# Access Compliance Report

## Public Rights-of-Way

Intersection ID: 46730	Main Street: HAMILTON_FOREST_DR	Cross Street: RUSTIC_VIEW_CT	Location: SE
ADA ID: AD00E010A87A	Ramp Type: PerpDiag	Initial Pass/Fail: Fail	Overall Compliance: No
			Severity Score: 33.75

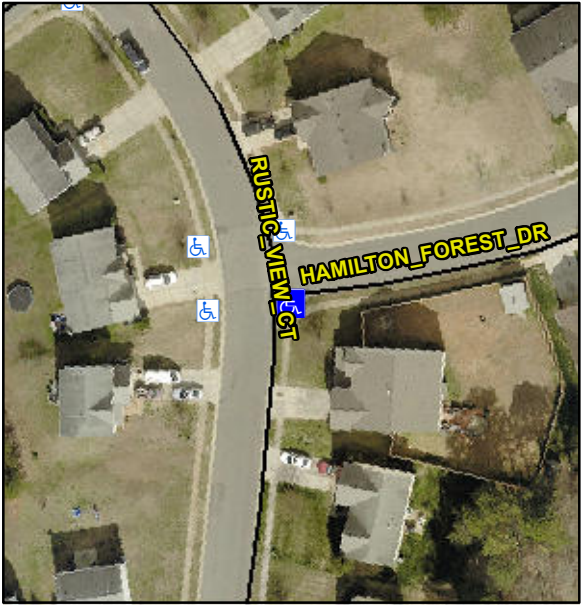
Codes/Mitigation Info/Possible Solution			Field Measurements/Component Compliance		
	Possible Solutions:		<b>Compliance</b>	<b>Description</b>	<b>Data</b>
	<b>Remove &amp; Replace Curb Ramp With Two New Directional Ramps or Equivalent.</b>		<b>No</b>	Ramp Length (in)	48.0
			<b>No</b>	Ramp Width (in)	39.0
			<b>N/A</b>	Flare Type LT	N/A
			<b>N/A</b>	Flare Slope LT (%)	N/A
			<b>N/A</b>	Flare Traversable LT?	N/A
			<b>N/A</b>	Landing Length (in)	N/A
			<b>N/A</b>	Landing Width (in)	N/A
			<b>N/A</b>	Landing Slope (%)	N/A
			<b>N/A</b>	Landing X Slope (%)	N/A
			<b>N/A</b>	Landing Curb? (Y/N)	N/A
			<b>N/A</b>	Shared Landing?	N/A
			<b>N/A</b>	Gutter Ponding?	N/A
			<b>N/A</b>	Gutter Lip Ht (in)	N/A
			<b>N/A</b>	Painted X Walk1?	No
				X Walk 1 Direction	To W
			<b>N/A</b>	X Walk 1 Width (in)	N/A
				X Walk 1 Slope (%)	2.5
				X Walk 1 X Slope (%)	5.2
			<b>N/A</b>	Ramp inside XWalk1?	N/A
<p>Surveyor Notes:</p> <p><b>N/A</b></p> <p>PROW/ADA:</p> <p><b>Not Found, R304.5.1, R304.2.2, R304.5.3</b></p>			<b>N/A</b>	Ramp Slope (%)	11.3

<b>No</b>	Ramp XSlope (%)	6.6
			<b>N/A</b>	Flare Type RT	N/A
			<b>N/A</b>	Flare Slope RT (%)	N/A
			<b>N/A</b>	Flare Traversable RT?	N/A
			<b>N/A</b>	DWS Provided?	N/A
			<b>N/A</b>	DWS Contrast?	N/A
			<b>N/A</b>	DWS Length (in)	N/A
			<b>N/A</b>	DWS Full Width?	N/A
			<b>N/A</b>	DWS Offset (in)	N/A
			<b>N/A</b>	Gutter Slope (%)	N/A
			<b>N/A</b>	Gutter X Slope (%)	N/A
			<b>N/A</b>	Painted X Walk2?	No
				X Walk 2 Direction	To N
			<b>N/A</b>	X Walk 2 Width (in)	N/A
				X Walk 2 Slope (%)	3.0
				X Walk 2 X Slope (%)	0.9
			<b>N/A</b>	Ramp inside XWalk2?	N/A
			<b>N/A</b>	Clear Space?	N/A
			<b>N/A</b>	Clear Space to XWalk (in)	N/A
<p>Total Cost:</p> <p>\$ 3200.00</p>			<b>N/A</b>	Storm Grate/Utility Hazard?	N/A
				Storm Grate/Utility Type	
			<b>N/A</b>		N/A
			<b>Yes</b>	Surface Condition? (G/P)	Good
